PARTS & SERVICE NEWS

REF NO.	AA00079
DATE	May 31, 2000

SUBJECT: PLATFORM MOUNTING BOLT CORRECTION
PURPOSE: Correct Assembly
APPLICATION: WA500-3LE Wheel Loader Serial Number A70001 and UP
FAILURE CODE: 547281
DESCRIPTION: 45mm bolt does not fit into the weldnut.

Figure 1

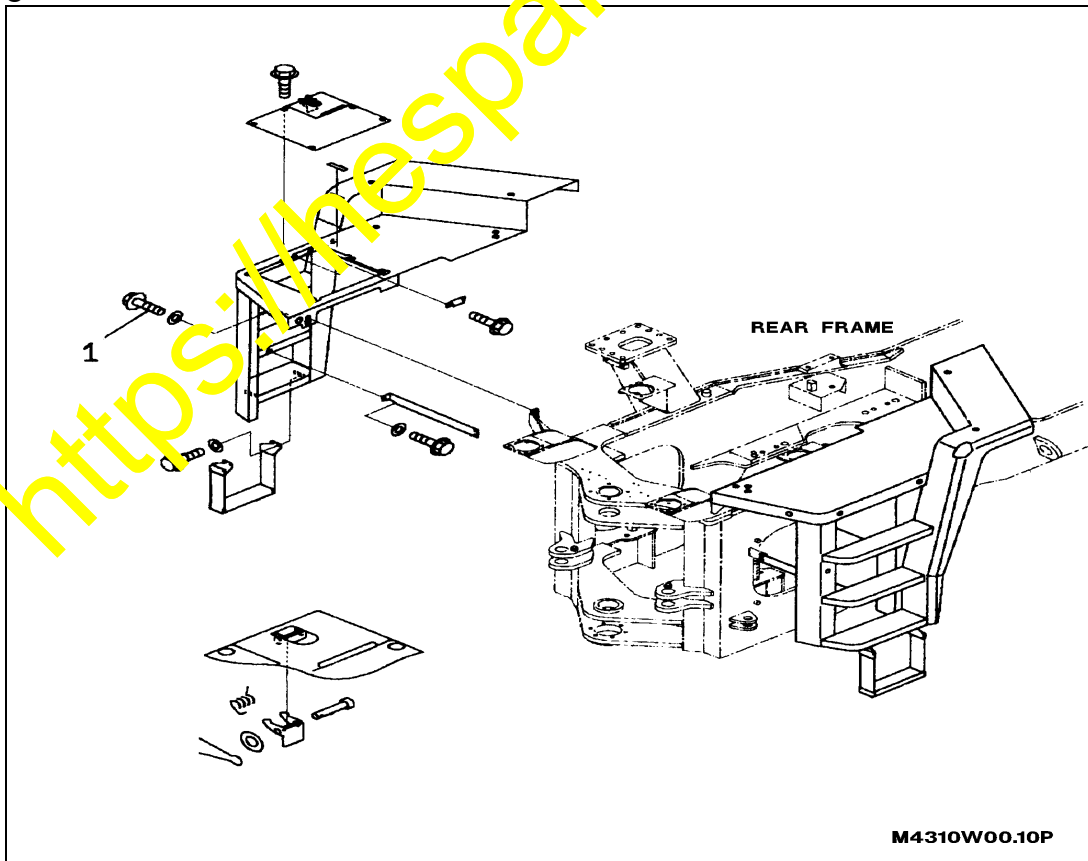
This PARTS AND SERVICE NEWS calls for a Parts Book update on the WA500-3LE. The original drawing has a mislabeled part.

Item	Part Number	Description	Qty	Remarks
1	01435-01245	Bolt	4	Change to Part Number 01435-01255

- See Figure 1 for location of mislabeled bolt.
